ET90000 Double Pole Relay Upgrade

Now Standard on 4, 8, 12 & 16 Circuit Models

Update on ET90000 Series (4 Circuits and Above)

Jumper Pin Configurations

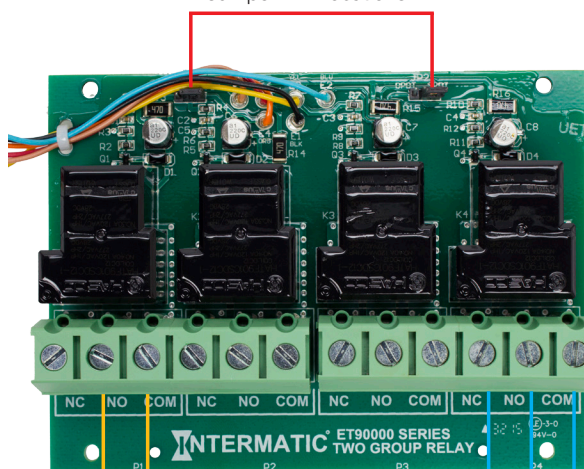
Now your controls can be configured to work as Double Pole relays for enhanced flexibility and peace of mind. If you currently use the ET90000 PC App, be sure to download the latest version of the PC App which has been optimized to support Double Pole configurations from Intermatic.com!

Jumper connecting pins 1 and 2 provide Double Pole (DPDT/DPST)

Jumper connecting pins 2 and 3 provide Single Pole (SPDT/SPST)
